CONFIDENTIAL SERVICE PHILCO

RADIO No. 26

DATE: 9-16-41

COMPLETE INFORMATION ON THE 1942 RECORD CHANGERS

FIGURE 1

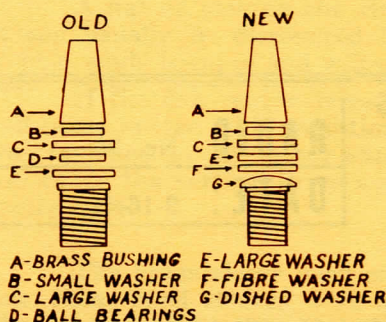
A. The rumble in the Models 42-1010 and 1016 can be easily corrected by replacing the turntable bearing. Remove the turntable and the spindle and then take out the brass cone and the ball bearings and washers. Rebuild the bearing, using the old washers and the new flat fiber washer and the concave steel washer. (See Figure 1). Add "Stay-Put Grease" or "Lubriplate" between the washers to eliminate friction. When replacing the spindle assembly, the spindle must be more than $\frac{1}{2}$ turn loose while lining it up with the record support shelf.

FIGURE 3

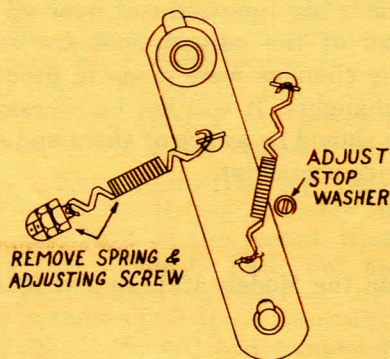
Remove the regeneration spring and the threaded adjusting screw and nuts. (See Figure 3).

There is a small fiber washer which is used to limit the motion of the upper bearing support assembly. (See Figure 3). Loosen the screw holding this eccentric washer. Hold the vertical drive shaft at approximately 3° to the right of perpendicular and adjust the washer and fasten in place. (See Figure 6).

FIGURE 5

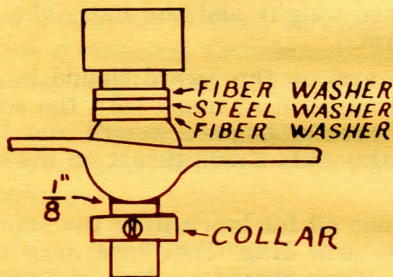
The change consists of removing the cupped washer and the flat washer below the upper bearing plate and adding two fiber washers, one on each side of the steel washers above the oilless bearing. The collar should be reset allowing approximately $\frac{1}{8}$ " clearance between the collar and the upper bearing support. The oilless bearing should seat in the upper bearing support and should not turn with the vertical shaft. (Figure 5).

FIGURE 4

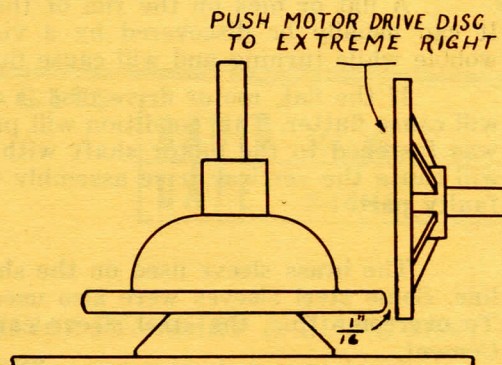
Push the motor drive disc and armature to the extreme right, against the thrust spring. Allow $\frac{1}{16}$ " clearance between the rim of the bell drive disc and the motor drive disc and tighten the two bearing screws securely. (See Figure 4).
